35/13-06O 15 West Lenox Street
Chevy Chase Village Historic District, 35/13

SUBJECT: Historic Area Work Permit #419729, rear pergola construction, front lamppost replacement, rear terrace alterations, and foundation-level window alterations

PROPOSAL: Construct rear pergola, replace front lampposts, alter existing rear terrace, and infill foundation-level windows

FRONT ELEVATION - W/ EXIST. BSMTH. SASHES
DAVID JONES ARCHITECTS
4.28.6

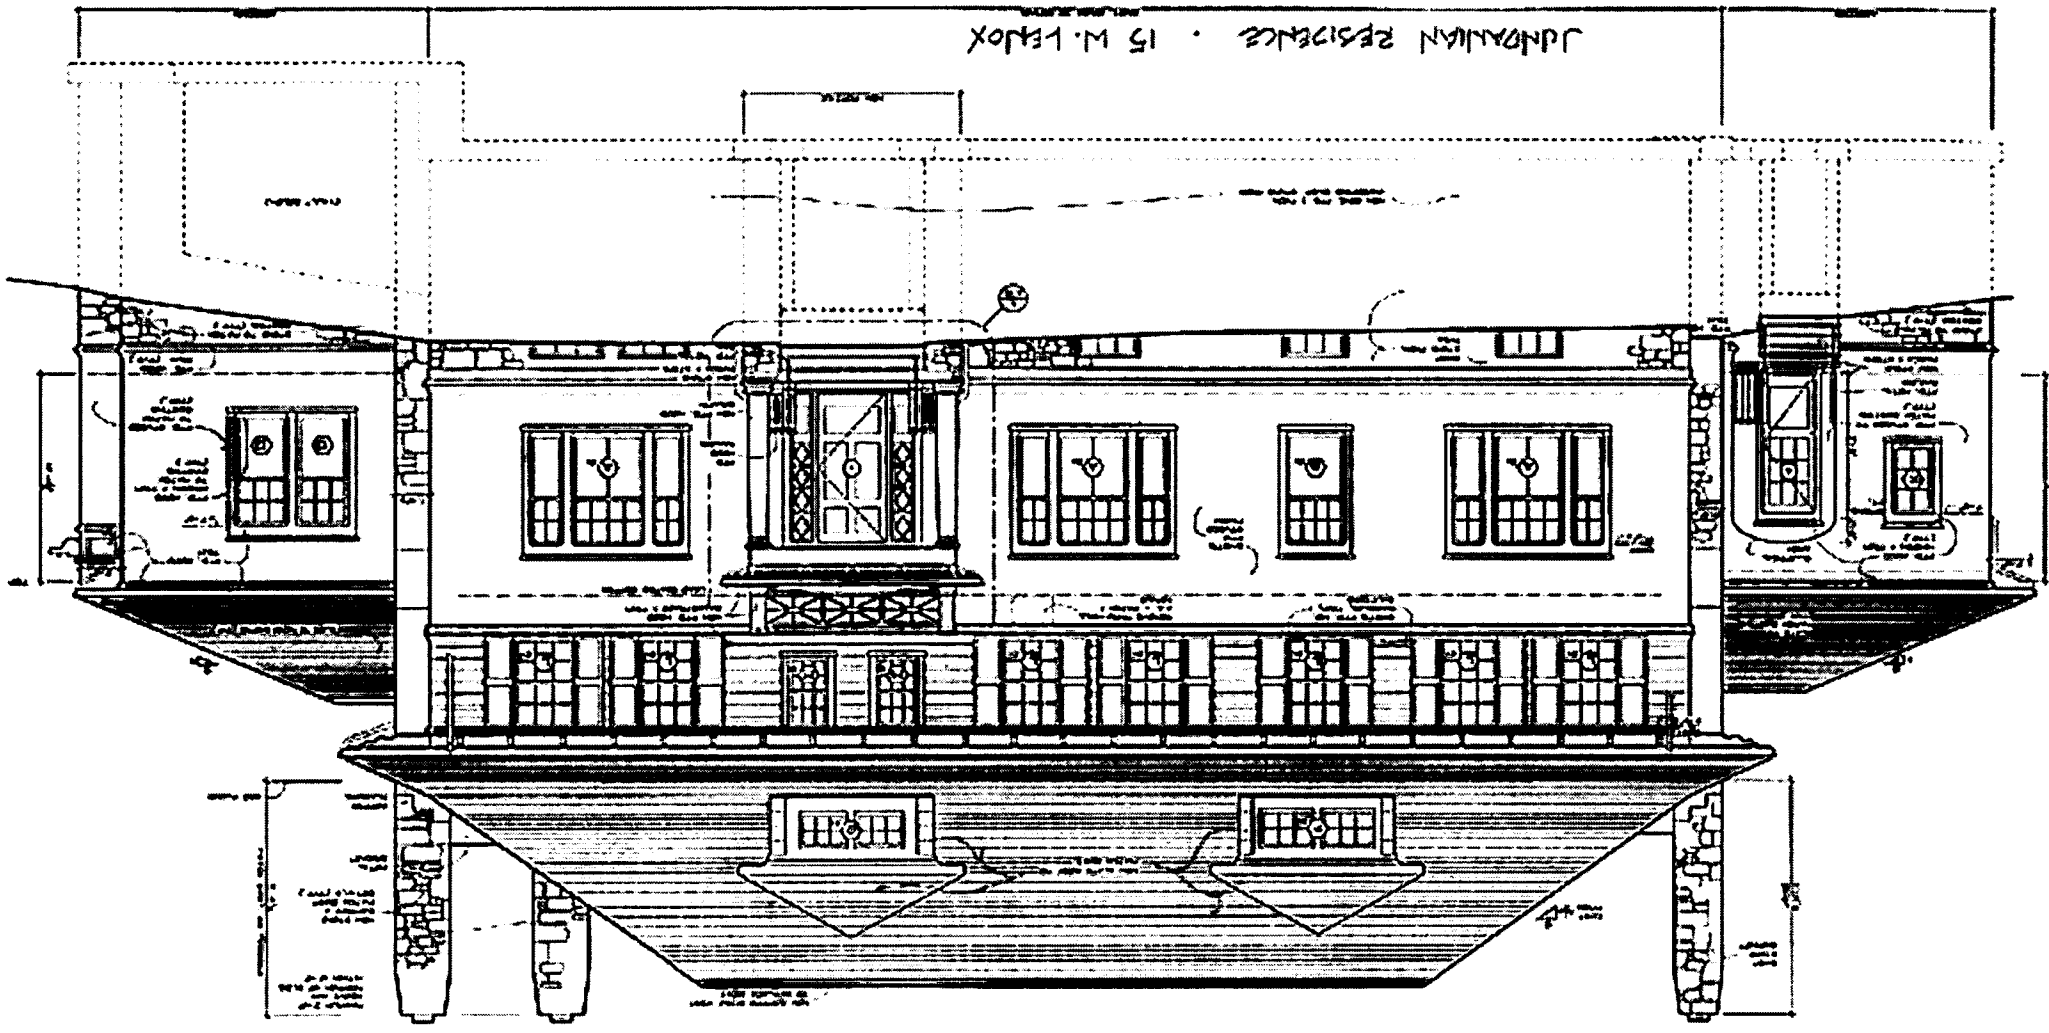
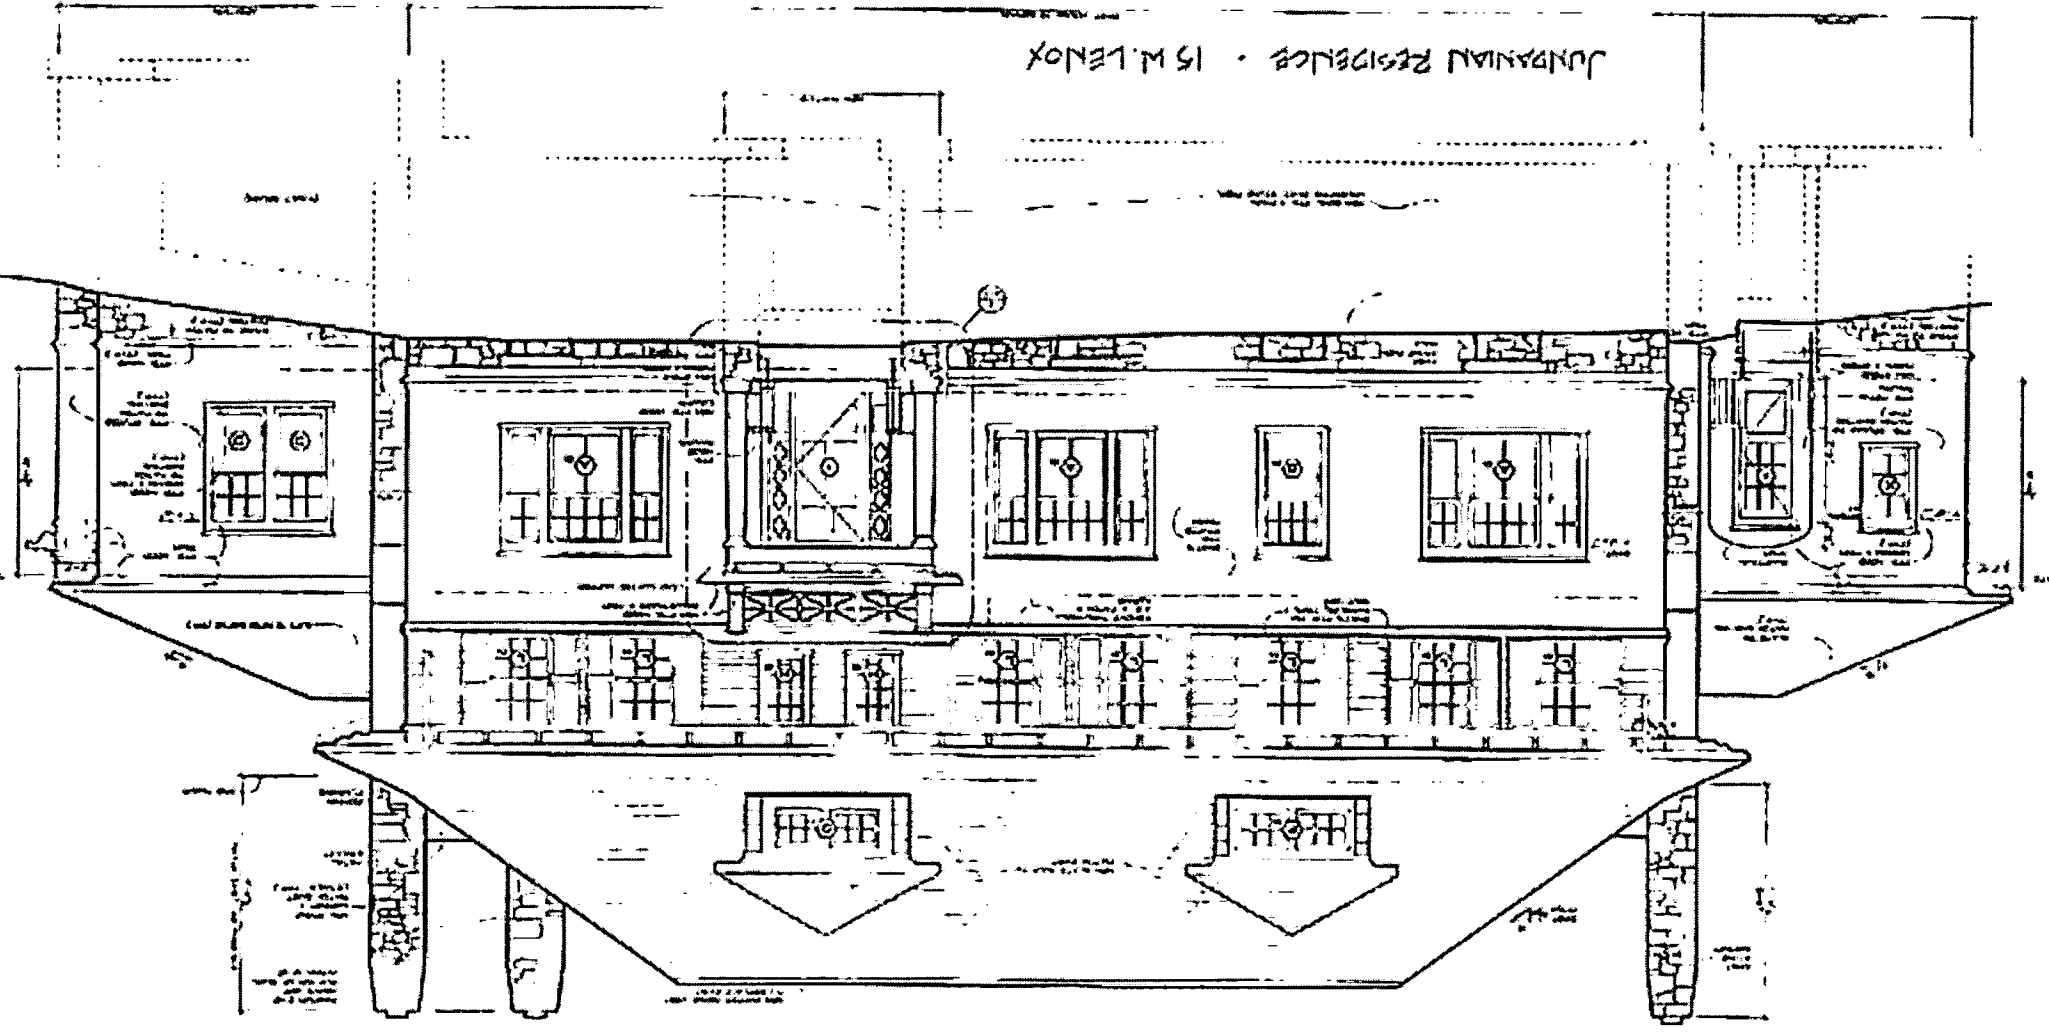
I have been asked to follow up with you regarding the basement windows on the front elevation of the Jundanian Residence. We do not plan to open up the existing windows to the basement. Is it possible to remove the units and infill the openings with stone? We would inset the new stone to create a slight reveal. This would help us water-proof the wall. I am including two elevations and a photo. Do you need anything more to discuss this at the working session?

Sheet	Date	Revised	Scale
	May 21, 2008		1/4" = 1'-0"
	Created by	Checked by	
<p>Details: Terrace Plans & Elevations</p> <p>L8.3.1</p>

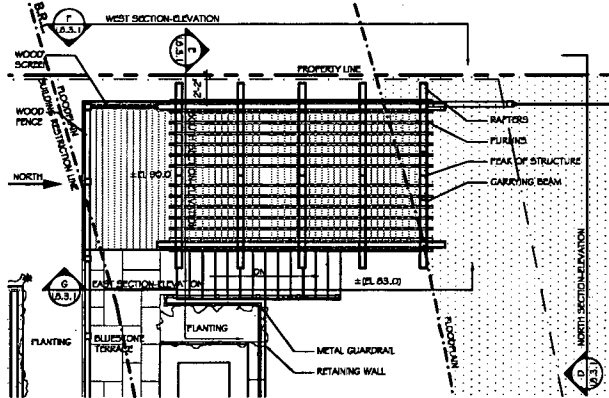
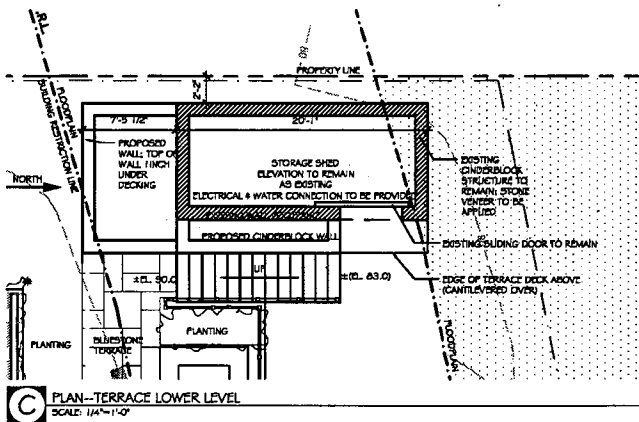
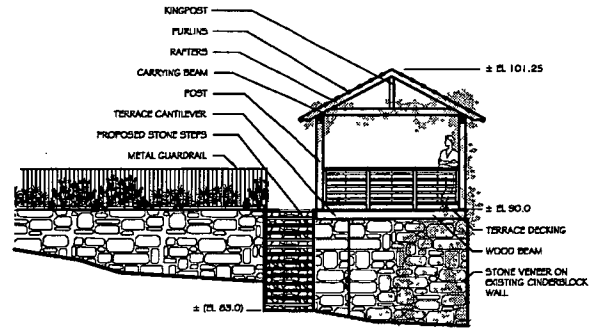
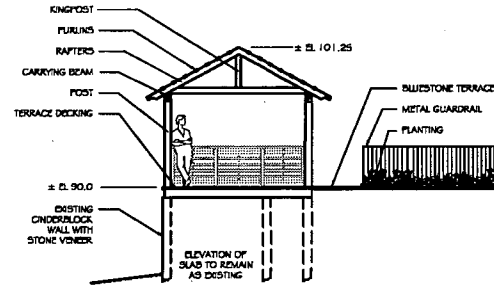
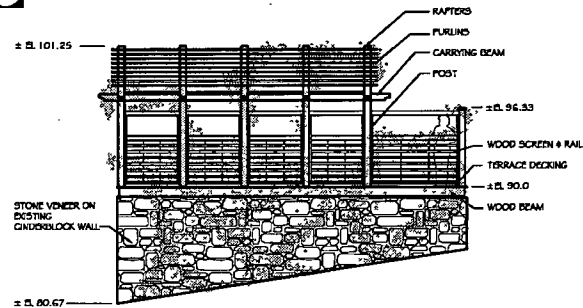
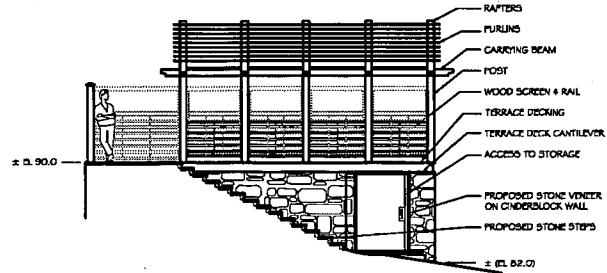
- The dimensions of the structure are changing in width only. We have proposed an addition of +/- 2'-9" to the terrace towards the East.
- Change in pitch of overhead structure to be less steep than original structure due to the fact that the terrace increases in width-but overall height will remain the same.

- Replace all old wood members (due to major decay and deterioration) with new wood members
- Enlarging posts from 4x4's to 6x6's for greater structural stability

- Adding a stone veneer to the existing cinderblock structure for aesthetic purposes
- Replace wood privacy shelves that span from top to bottom (on West side) with wood decorative railing that is 4'-1" tall

- Replace plain wood railing (vertical wood members with 2 horizontal members) on North and East side of the terrace with a more decorative wood railing (7 horizontal members with minimal vertical members intersecting at even intervals) that is the same height as existing railing

- Add retaining wall to area where erosion is occurring towards neighboring property

- Add cinderblock wall (towards the East) to support the area of the terrace that has increased in width
- Replace old purlin design (multiple purlins spaced close together) with new purlin design (fewer purlins spaced further apart)

The appropriate guidelines for each proposed change have been listed previously in this report. The replacement of the lampposts with new lampposts that are compatible with the house and located in the same site is an allowable change. The front foundation level window removal was requested to resolve existing water penetration issues which could lead to damage to the foundation and house, and the HPC generally allows foundation level window changes in a Contributing Resource, even on the front elevation. The addition of a pergola at the back of the house attached to the addition is allowable as it is at the rear and would have minimal impact on the house. The structural, design, and material changes to the existing rear wood terrace and walls are also approvable as they are appropriate and compatible with this house.

Sheet #	Title	
LP-3	Proposed Lighting	
	Date	Scale
	May 3, 2005	N.T.S.

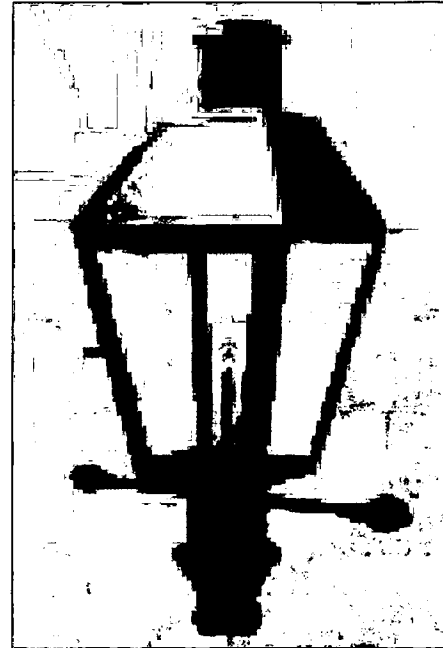
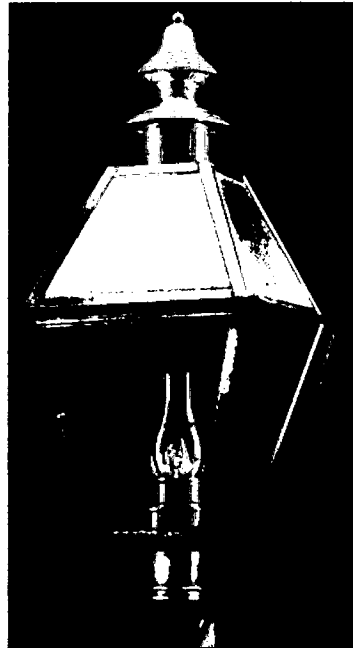
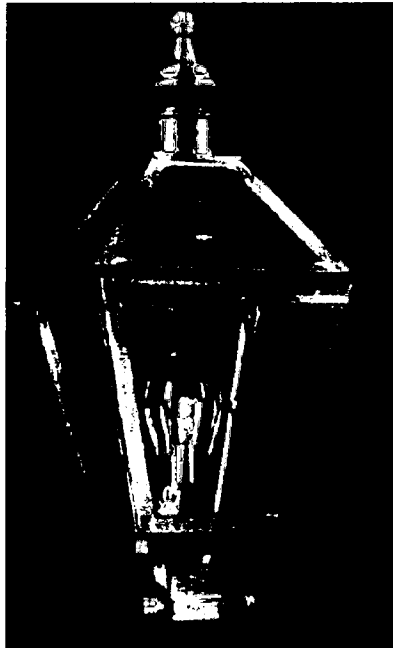
1. Replace the front metal lamps and lampposts with gas lanterns and metal lampposts in the same location (see Circles 8-10).
2. Install a wood pergola on the rear left terrace off the approved screened porch (see Circles 11-14).
3. Remove the foundation-level windows on the front elevation and infill the openings with stone to match the stone foundation (see Circles 16+17).
4. Renovate and expand the existing wood terrace in back yard (see Circles 20-23):
 - a. widen the existing terrace 2'9" to the east
 - b. change the roof pitch -- roof will be less steep and have a new purlin design
 - c. enlarge posts from 4 x 4s to 6 x 6s for stability
 - d. add stone veneer to existing cinderblock structure below the terrace
